# NORTH BRANCH

**PLANNING COMMISSION  
REGULAR AGENDA  
TUESDAY, JULY 1, 2025 @ 6:30 PM  
CITY HALL, 6408 ELM STREET, NORTH  
BRANCH, MN 55056**

MAIN STREET APARTMENTS  
 OWNER: TOMMY FOSTER  
 1275 WEST 4TH ST, RUSH CITY, MN

ELEVATION  
**A1.1**

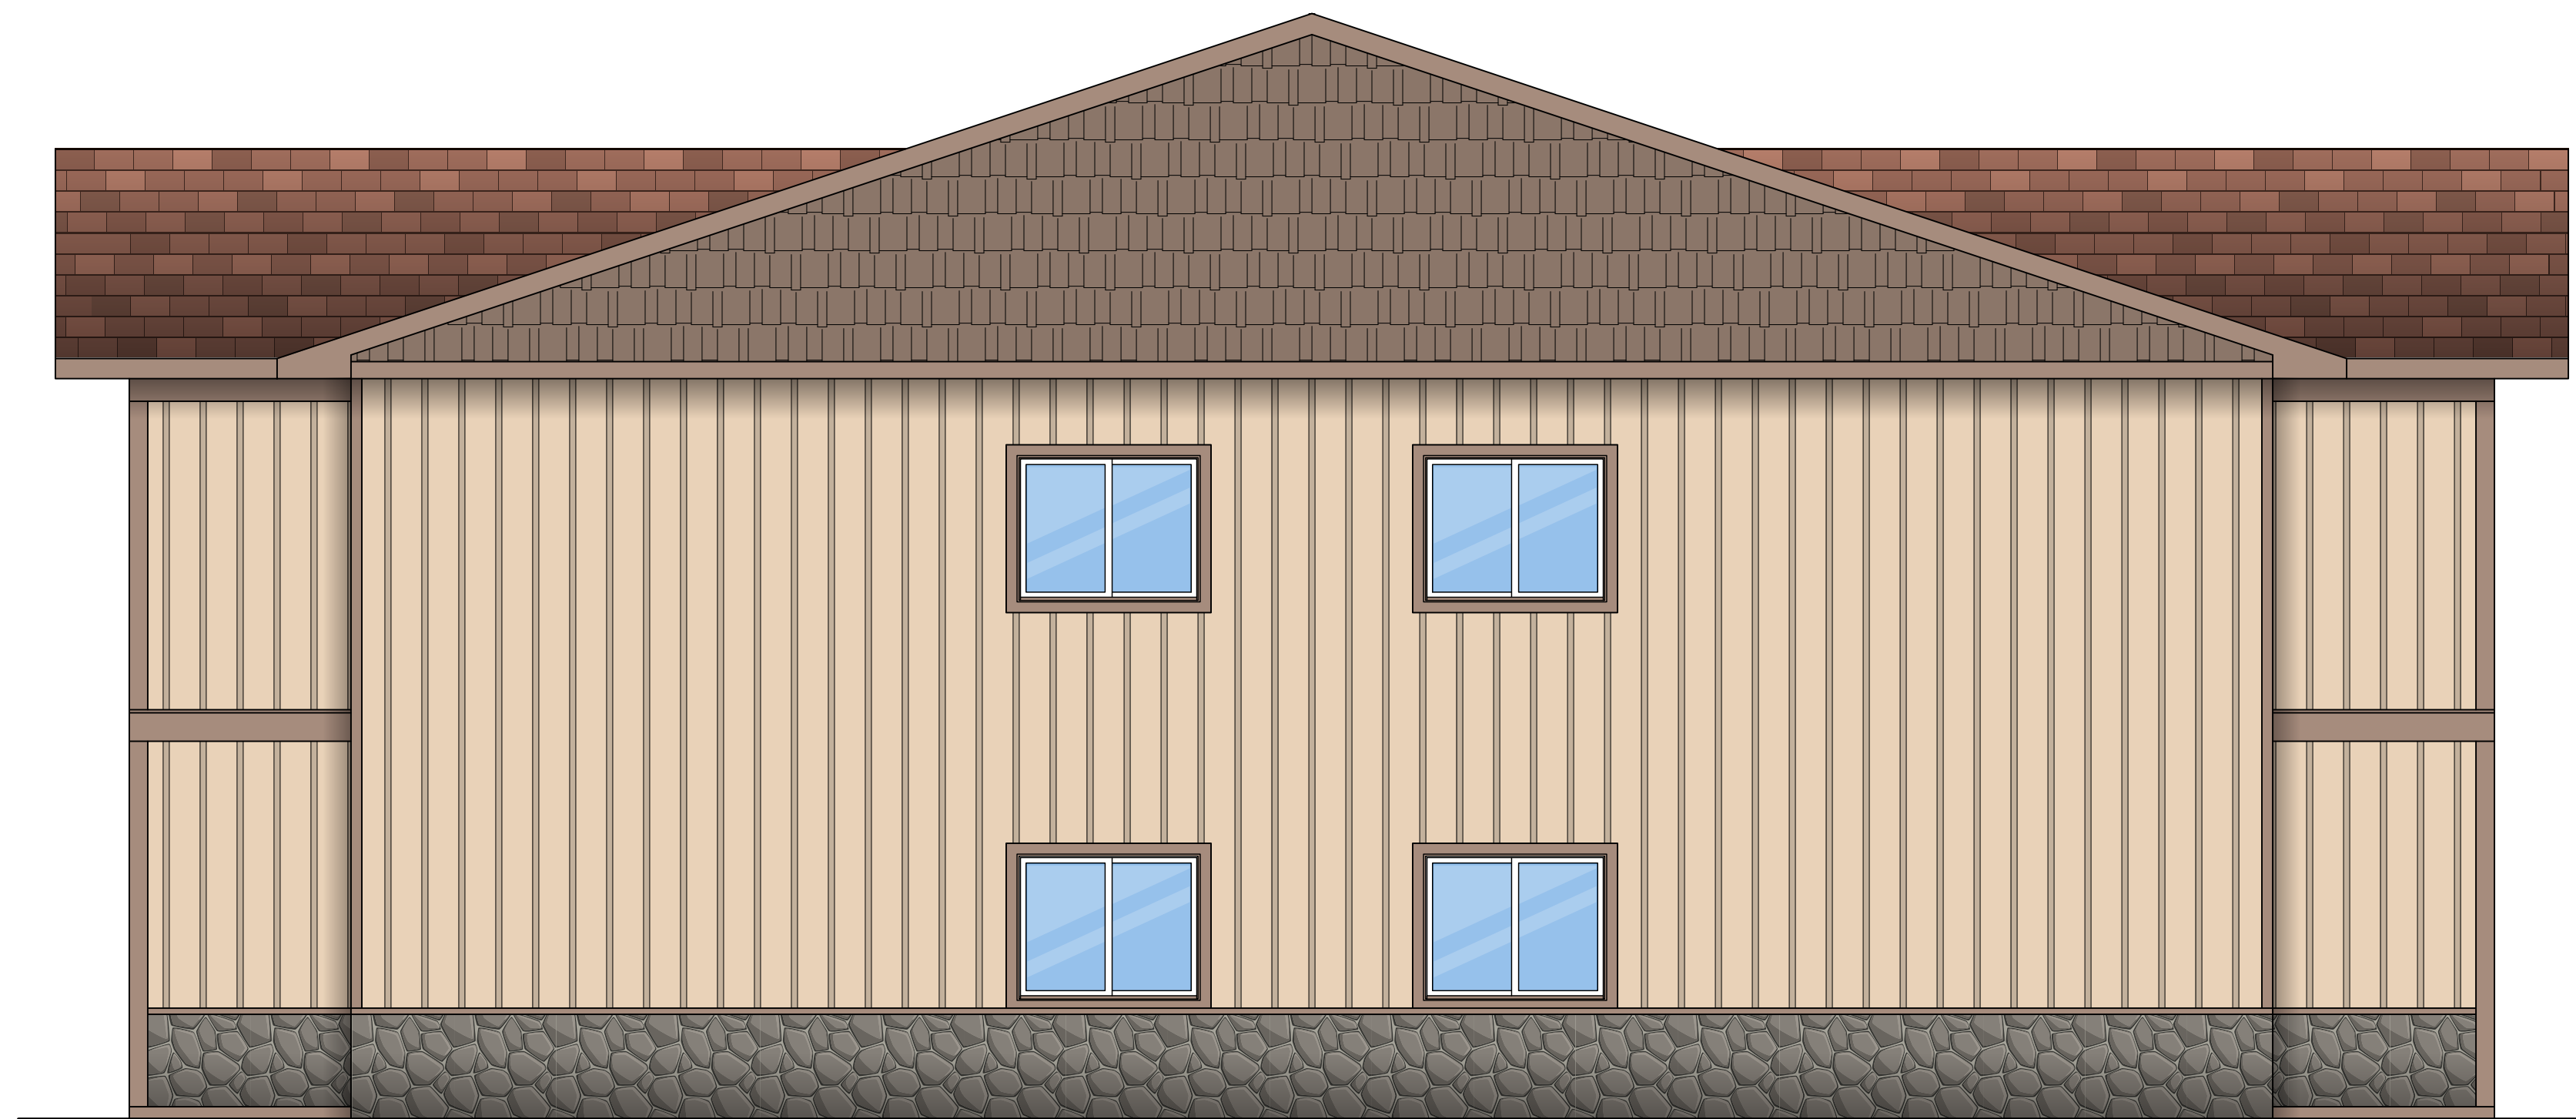
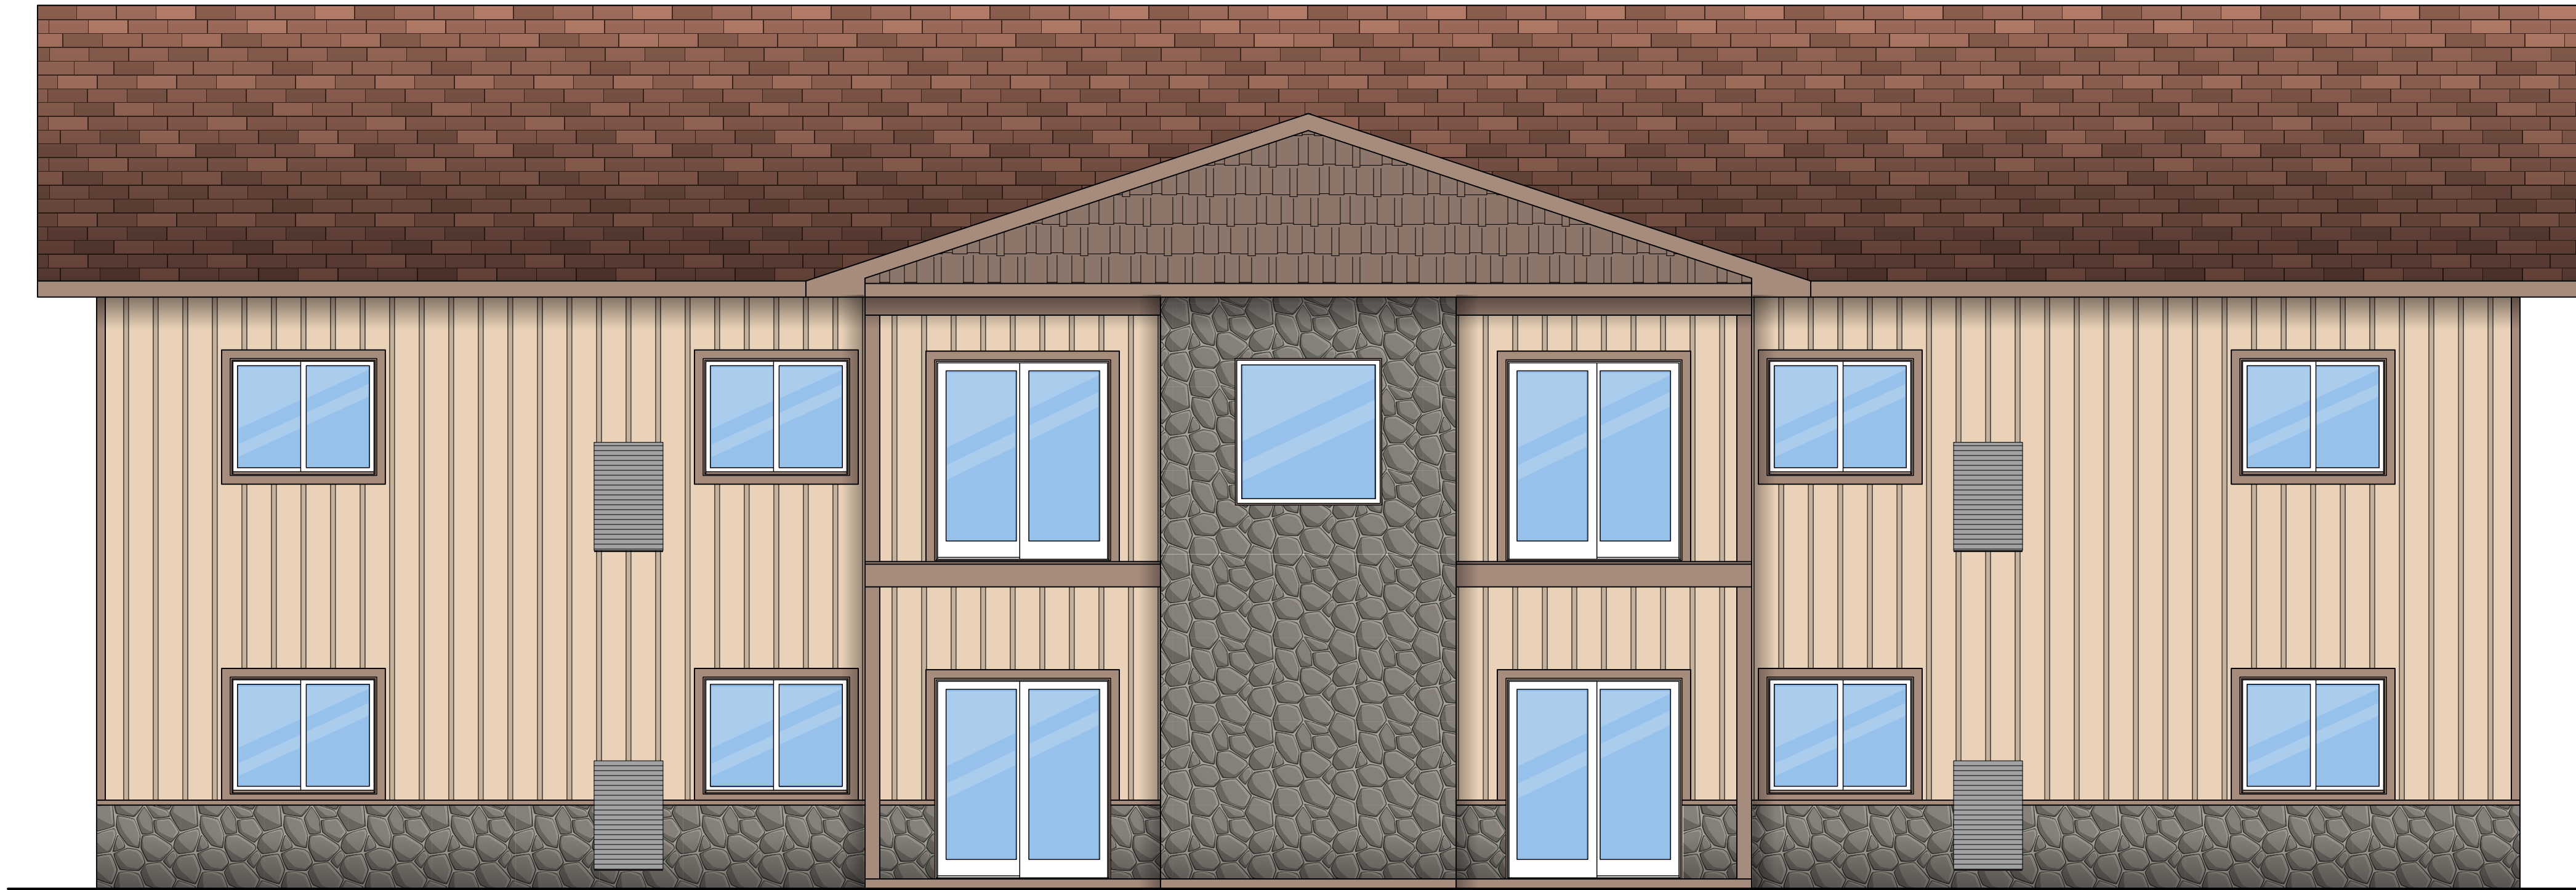
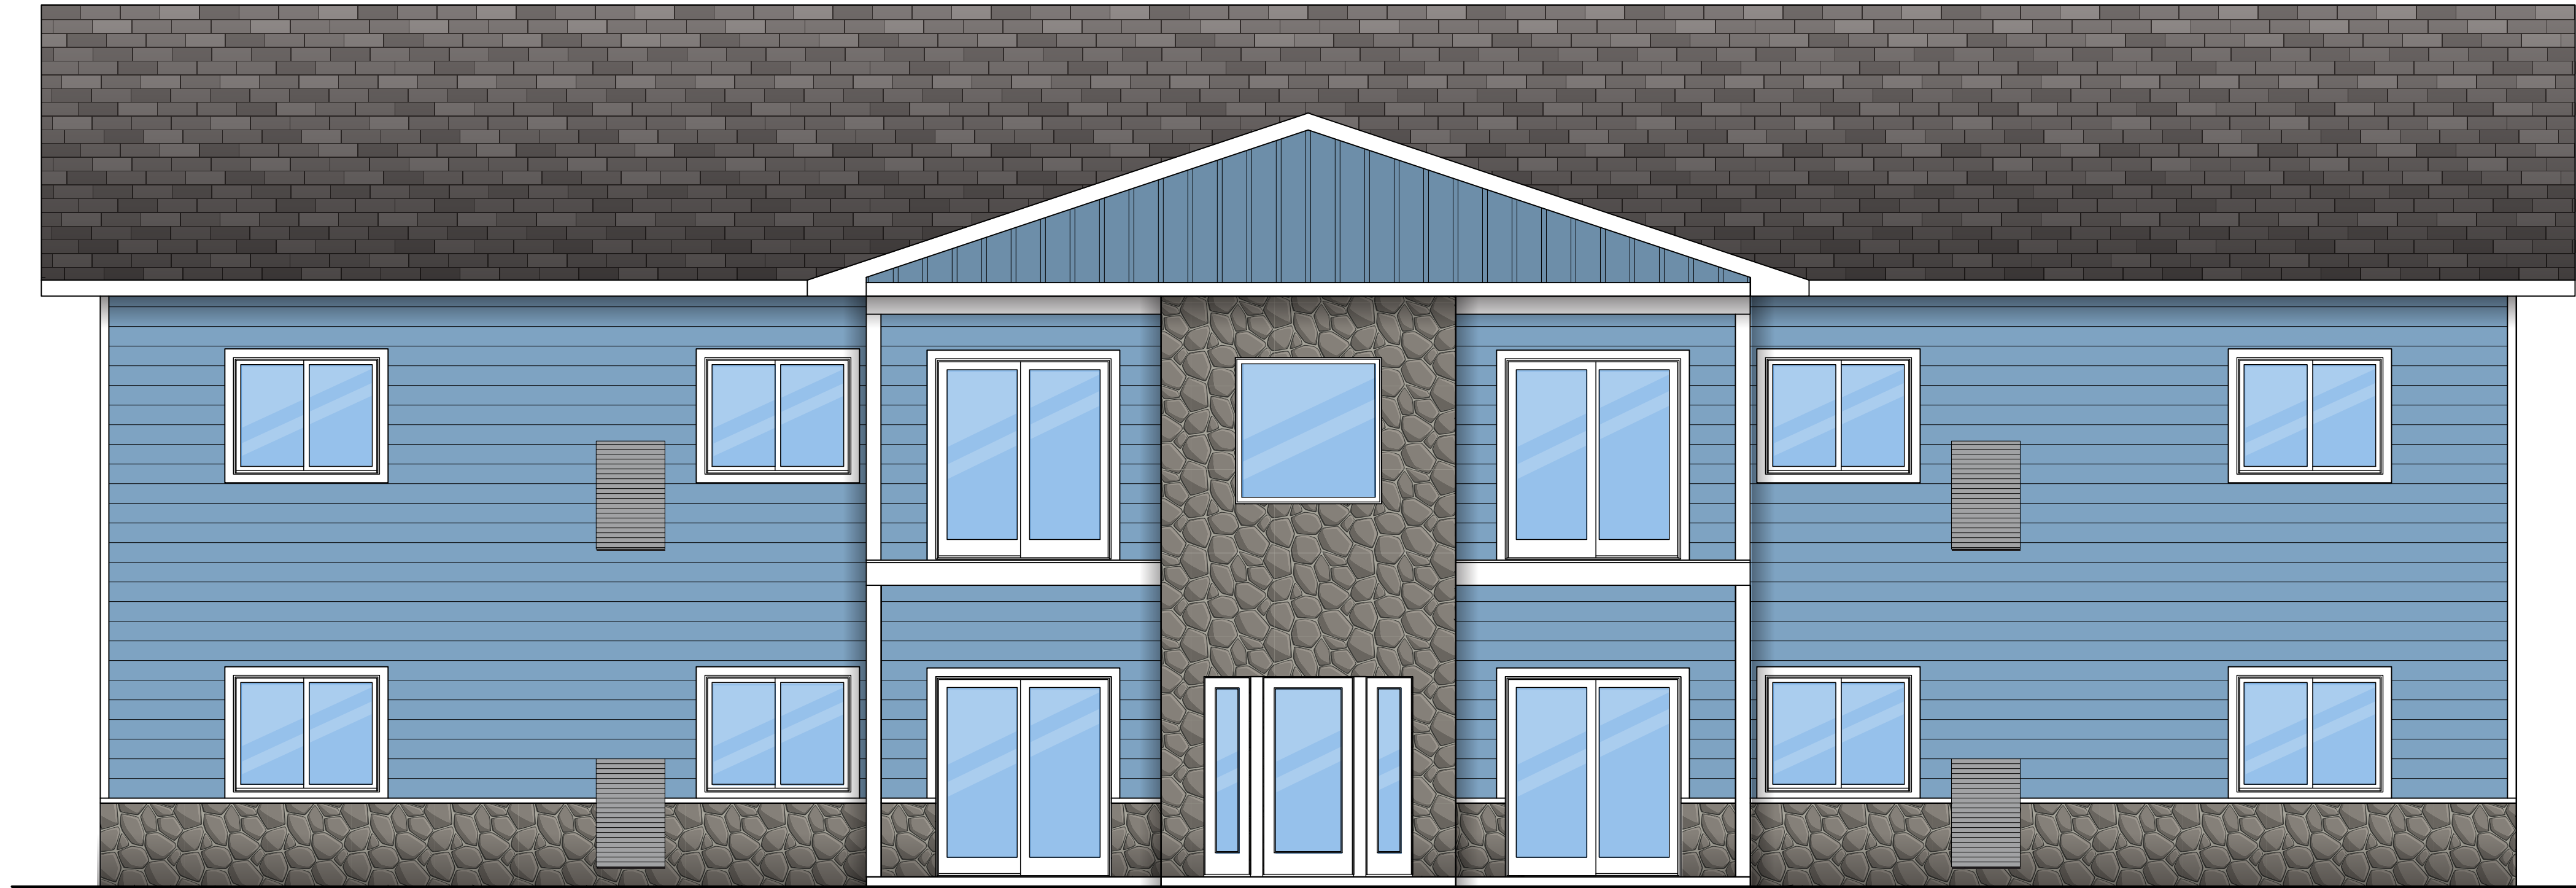
The ordinance requires building elevations with type and color of building materials, typical floor plans, dimensions of all structures and location of exterior buildings and equipment. The site is located in Zone 1 which requires that “Structures must provide a cohesive architectural appearance reflecting its functional purpose and must be composed of at least 65% Class I materials and not more than 35% Class II materials. Class I materials consist of brick, natural stone, glass curtain wall, copper or other comparable materials. Class II includes concrete block, precast concrete panels, masonry stucco, fiber-cement exterior siding, EFIS, smooth and scored block, and other similar materials.

In some instances, there could be some recognition other project attributes which would allow some reduction in the exterior materials requirements. However, in this instance the landscape plan and the site design do not provide any reason to vary from the current materials standards. As noted previously, this is a high visibility site both due to its location and lack of topography and the city is interested in having a project that sets the tone for future development and redevelopment in the downtown area. The lower quality building materials vary greatly from the ordinance criteria, and staff does not support the plan as proposed.

The developer has provided a revised landscaping plan to address screening along the east side of the site. along with revised building and architectural plans to meet the city design standards.
